Wisconsin Department of Transportation

Proposal #13: 1009-43-76
2026/2027 Statewide Tree Clearing
NC Region Various Counties
Non HWY
NC Region Wide

This is Addendum No. 01, which provides for the following:

ADDENDUM NO. 01**1009-43-76****August 27, 2026****Special Provisions****4. Consideration of Proposals (Indefinite Delivery/Indefinite Quantity).**

PROJECT NO: 1009-43-76	HWY: STH 110	COUNTY: WAUPACA	TREE CLEARING	SITE: 05	SHEET 30	E
FILE NAME: C:\2023\022024 - WISDOT STH 110\DESIGN\8&T\06\990-02-72\DRAWINGS\72_TREE CLEARING PLAN SHEET.DWG	LAYOUT NAME: 02	DATE: 8/20/2026 8:04 AM	BY: KEVIN JORDAN	SCALE: 1"=40.0'	WISDOT/CADDS SHEET 44

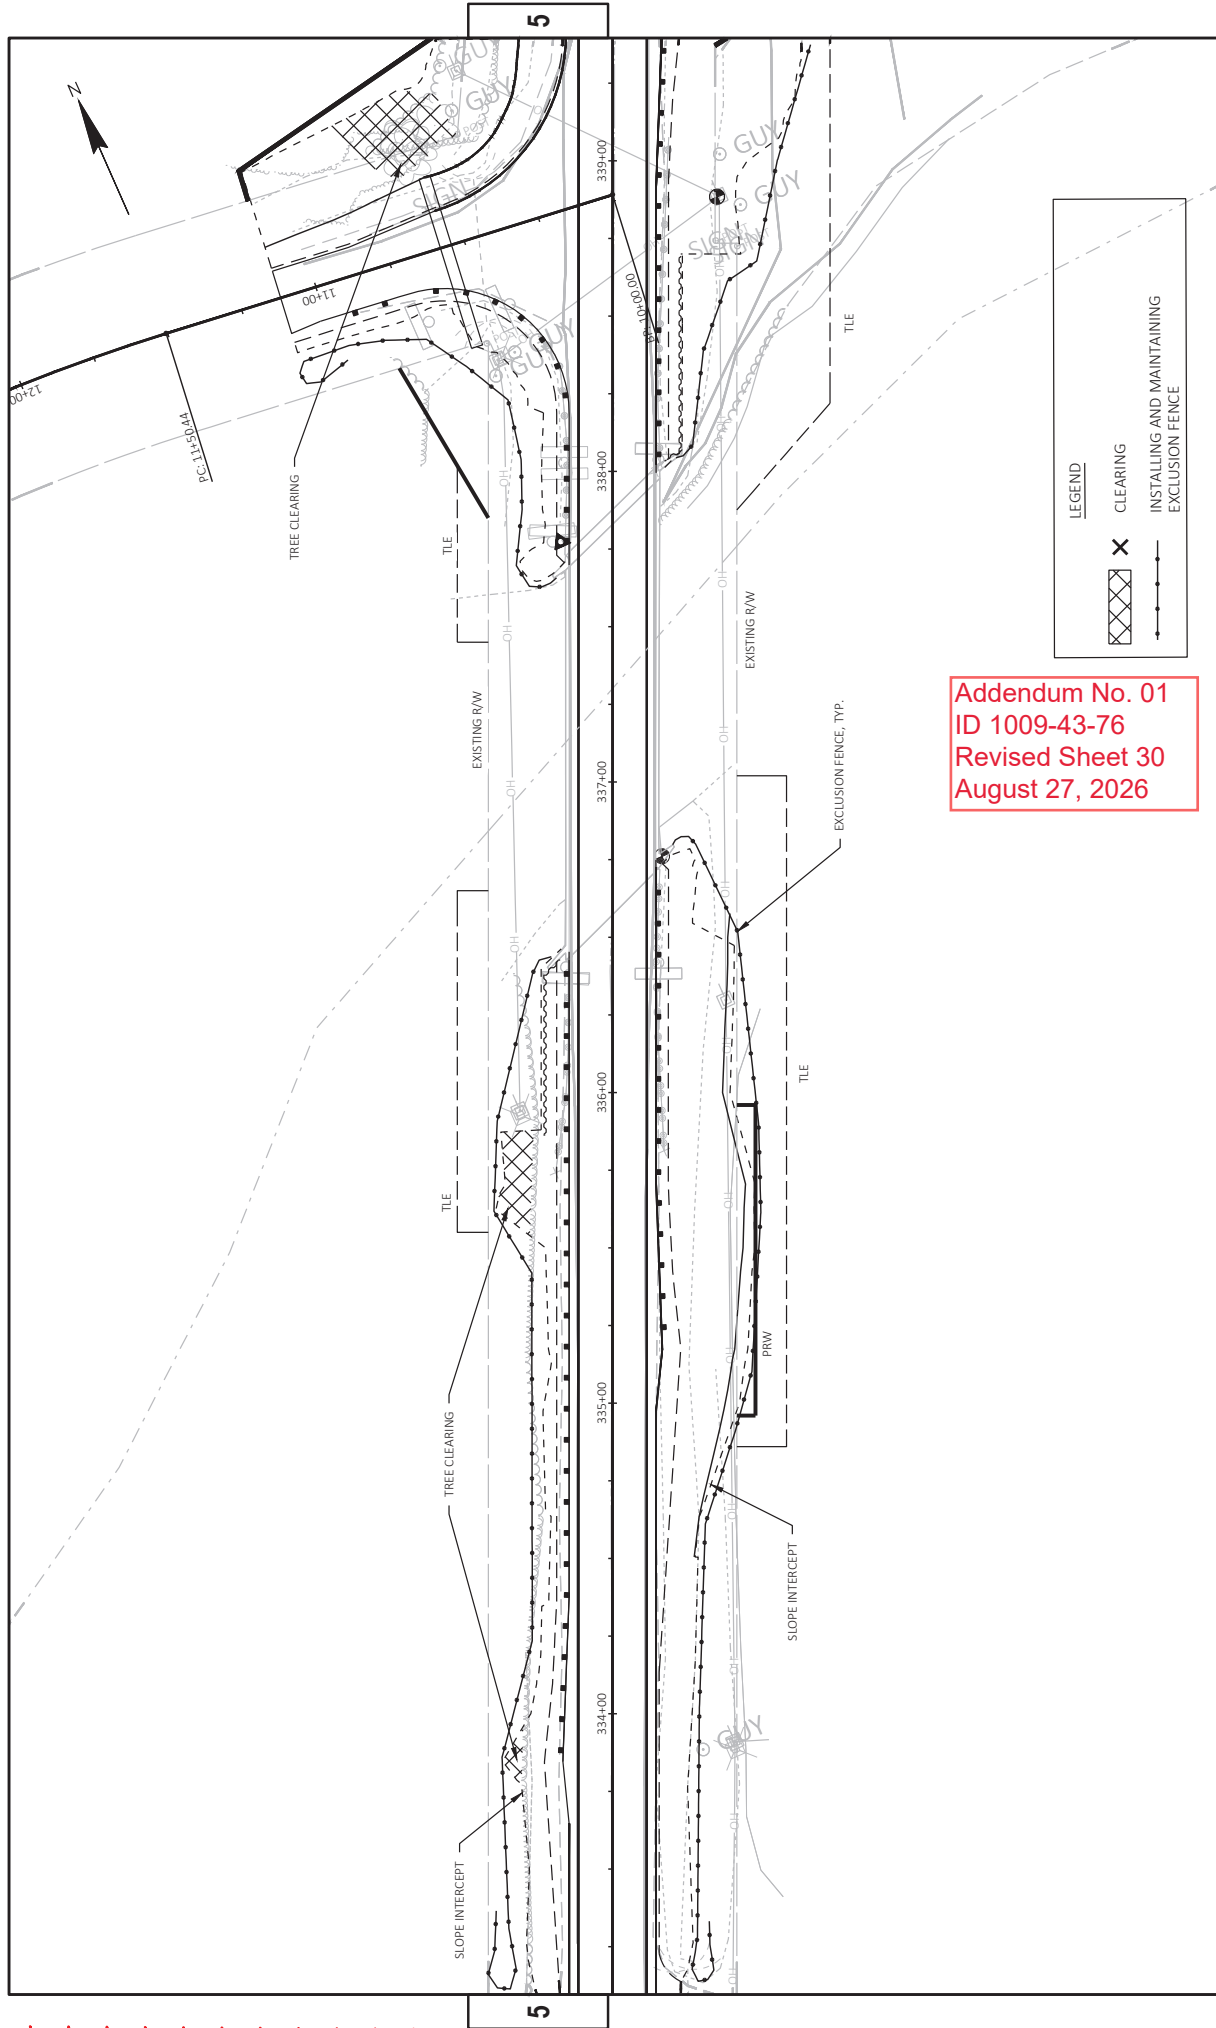
Revised Plan Sheets	
Plan Sheet	Plan Sheet Title (brief description of changes to sheet)
2	Remove all references to Site 18 work on state diagram and table
5	Update quantity table for Clearing
30	Replace Tree Clearing sheet with updated fence locations
101	Update Spectrum contact information
104-106	Replace with updated sheets with new fencing locations

PROJECT NO: 6590-02-73	HWY: STH 110	COUNTY: WAUPACA	EROSION CONTROL	SITE: 06	SHEET 33A	E
FILE NAME: C:\2022\022024 - W8001 STH 110\DESIGN\PA&T\06590-02-73\73 DRAWINGS\73_TREE CLEARING PLAN SHEET 06.DWG	8/20/2026 8:47 AM	KEVIN JORDAN	1 IN/40 FT	W8001/CA005 SHEET 42

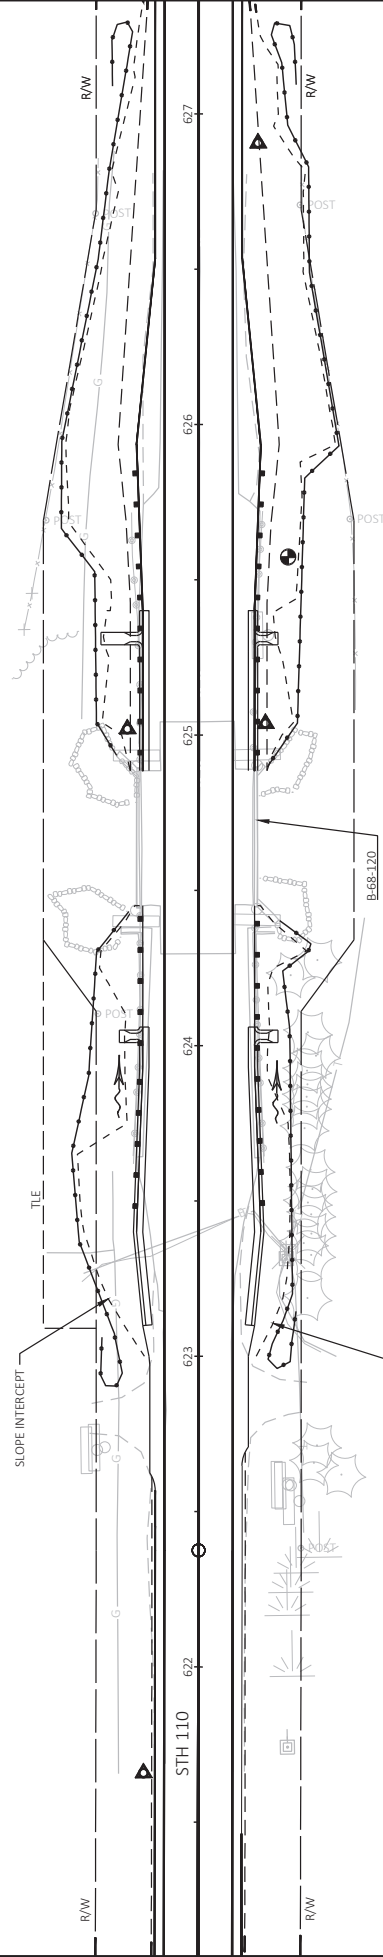
Added Plan Sheets	
Plan Sheet	Plan Sheet Title (brief description of why sheet was added)
33A	Add the new exclusion fence plan sheet
